Title: ERID-111328 SUBMITTAL OF THE RESPONSE TO THE NOTICE OF DISAPPROVAL FOR THE INVESTIGATION WORK PLAN FOR LOWER PAJARITO CANYON AGGREGATE AREA AND REVISION 1, INCLUDING 2 CD'S, EP2010-0521, EP2010-0522, LA-UR-10-7635

To:(Addressees - Organization) JAMES BEARZI, NMED

From:(Senders - Organization) MICHAEL J GRAHAM, LANL
 GEORGE J RAE, DOE

Figure 4.9-2 Proposed sampling locations for SWMU 18-003(e)

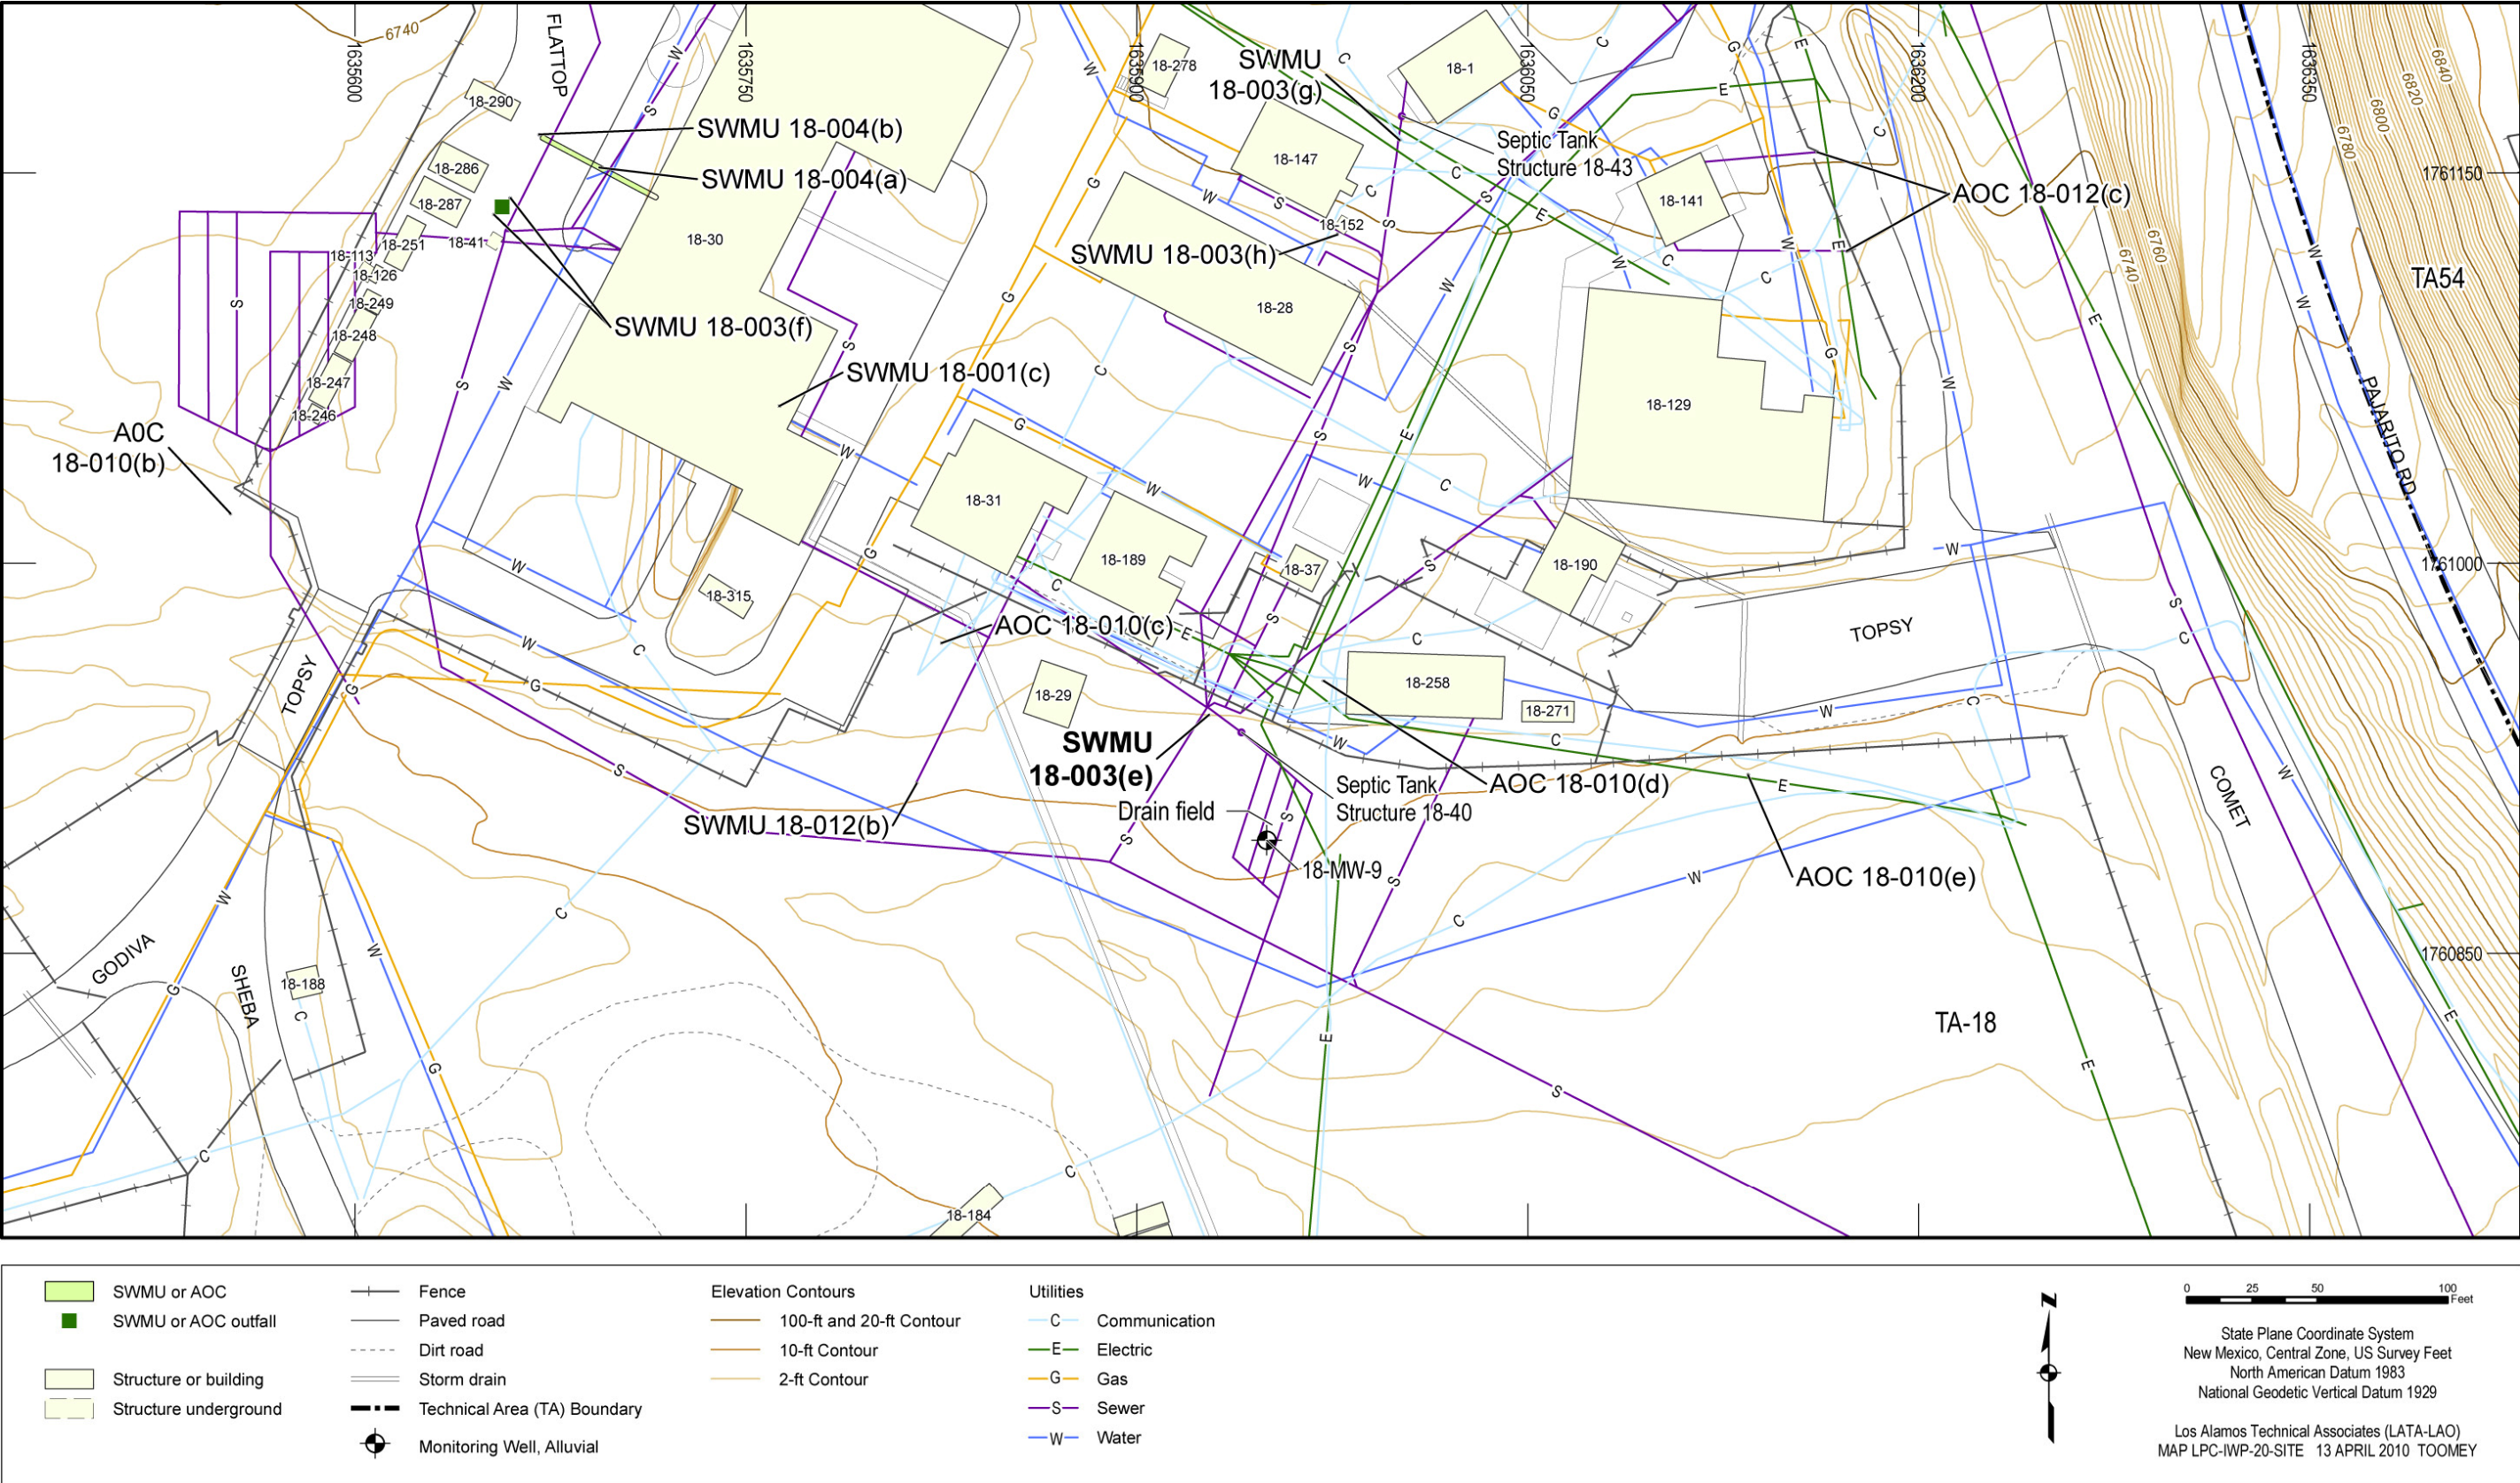
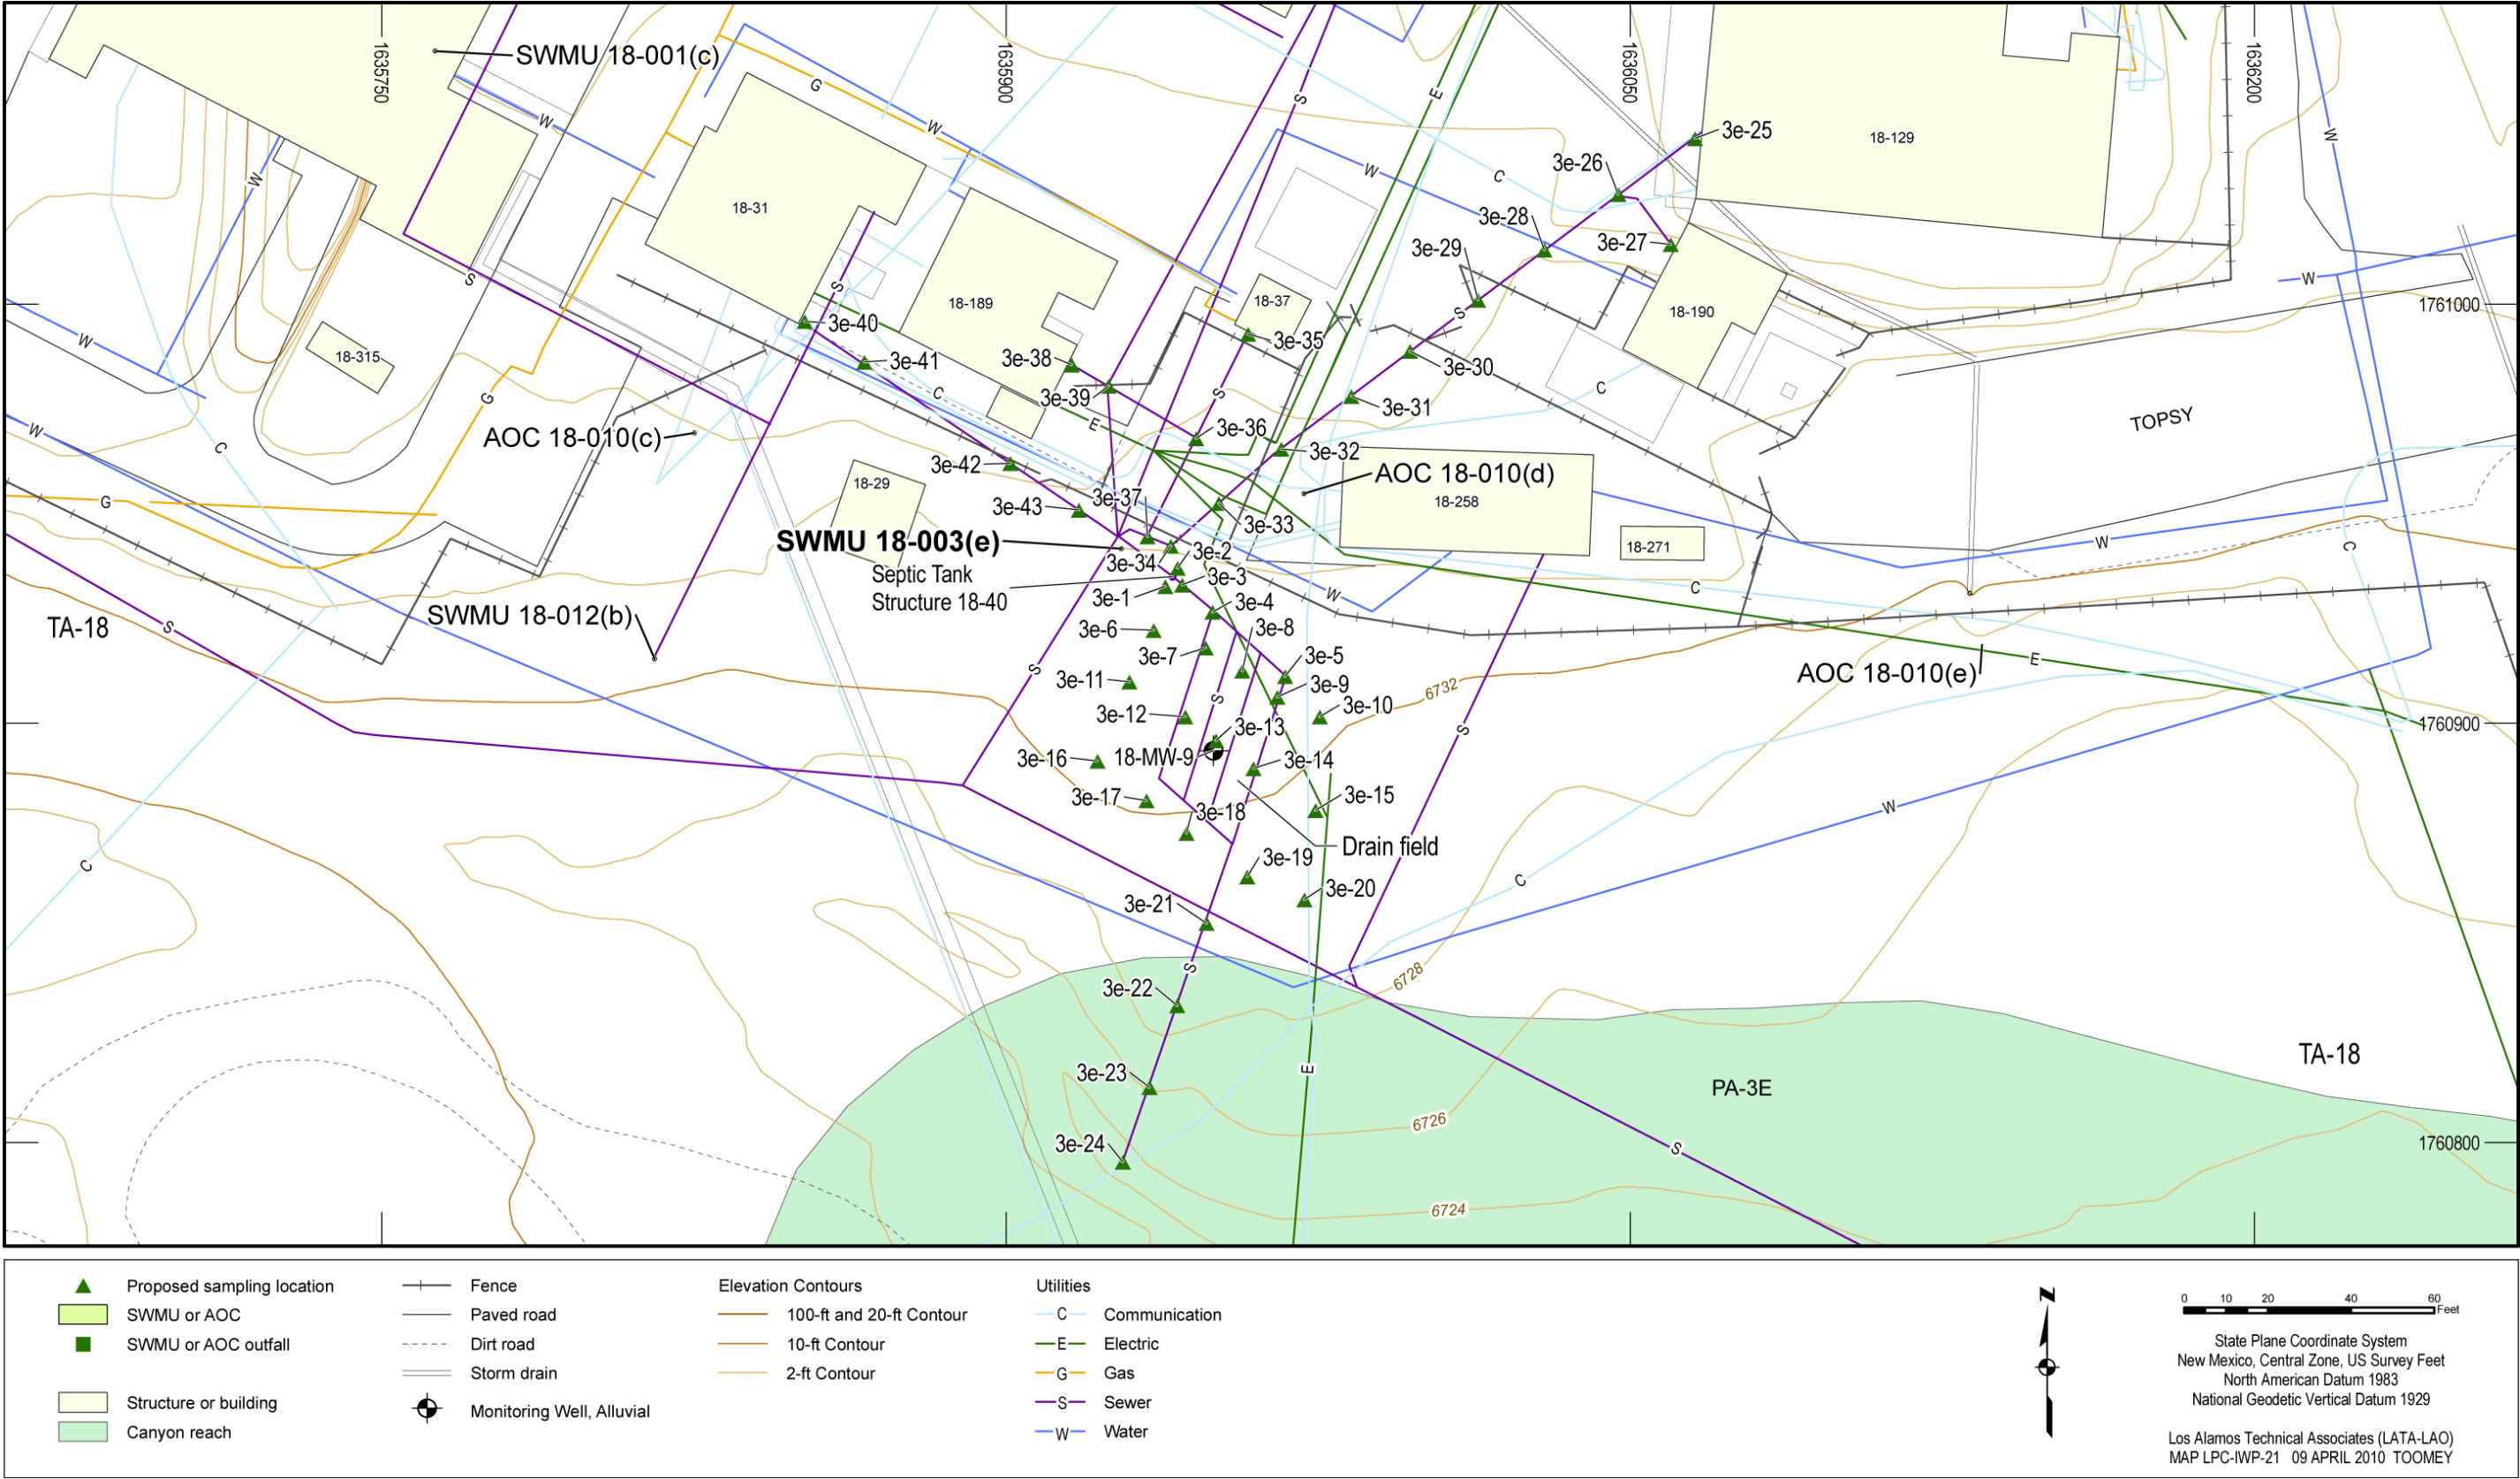
Plan Plate 1 indicates well 18-MW-9 is close enough to the SWMU to include its location on Figures 4.9-1 and 4.9-2. It is possible the well may be located in or very close to the drain field associated with the SWMU. Revise the figures to show the well location and indicate that all 2011 groundwater monitoring data for the well will be included in the IR.

14. Figures 4.9-1 and 4.9-2 have been revised to include the location of well 18-MW-9. The text in section 4.9.3, Figure 4.9-2, and Table 4.9-1 have been revised to include 19 additional sample locations. The locations are proposed at the exits of buildings 18-31, 18-37, 18-129, 18-190, 18-189,
